ADDENDUM

Project Name: Health Life Safety Work: Exterior Improvements at: Quincy Junior High School

Addendum Number: 1

Issued: 04/11/2019

4 NORTH ELEVATION AT SOUTH COURTYARD
SCALE: 1/8" = 1'-0"
(NORTH COURTYARD SIM.)

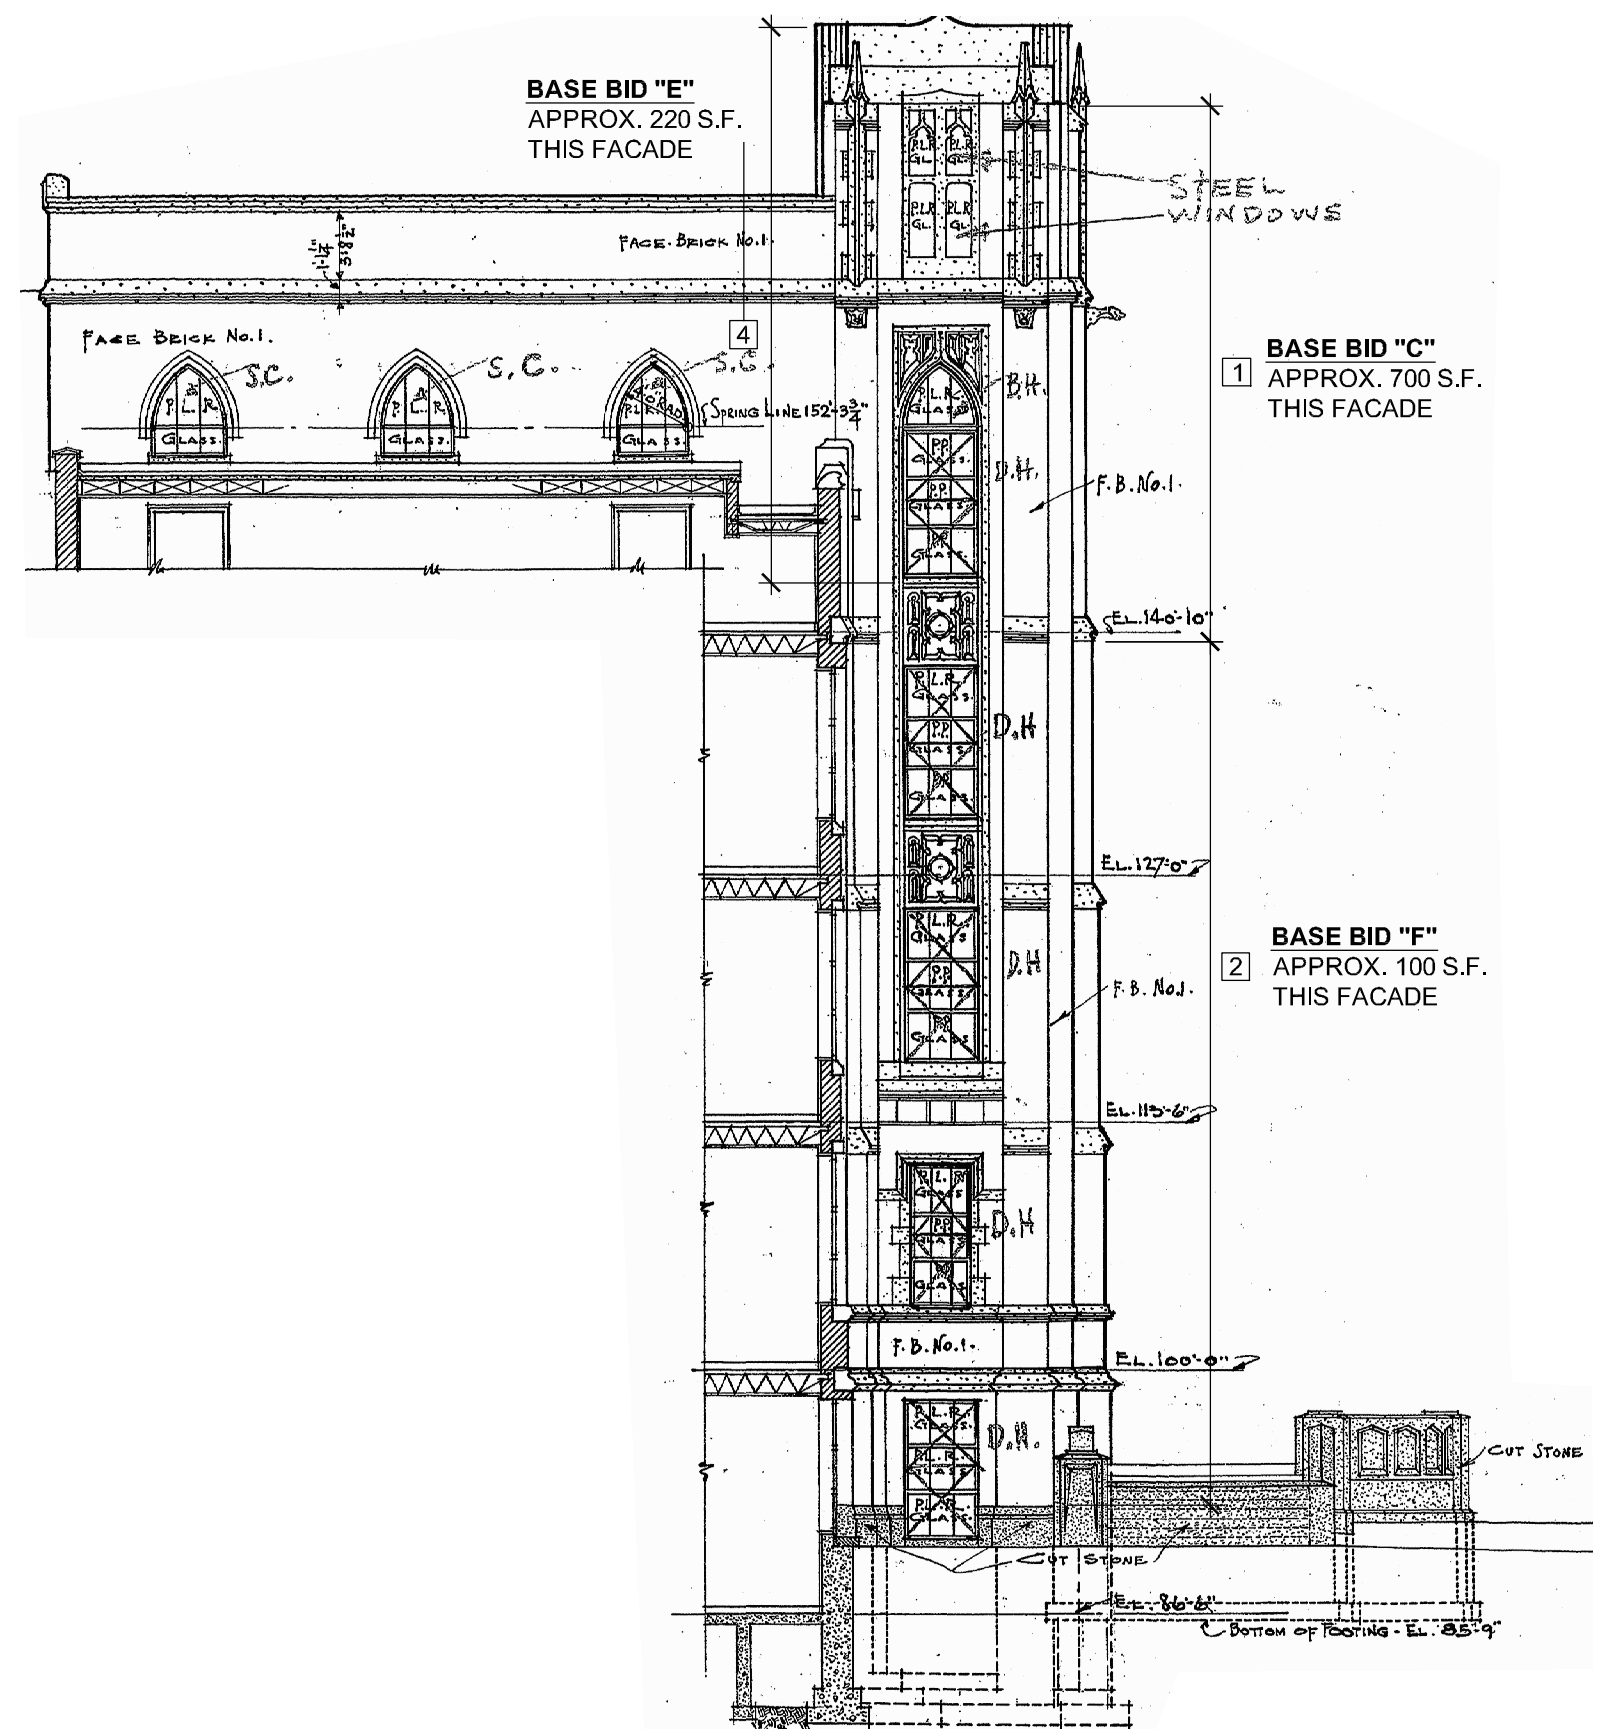
Section 01 5000 Part 3.4	Add	Section "I" - Provide temporary barriers as required to protect existing exterior doors.
Section 01 7000 Part 3.2	Add	Add paragraph "C" - Repair all damaged lawn and landscape areas to original condition.
Section 04 0140.61	Add	The "Matrix" repair system by Conproco is an acceptable product for stone repair.
DRAWINGS:		
A203	Revise	Lintel detail marks have been updated, see attached drawings.
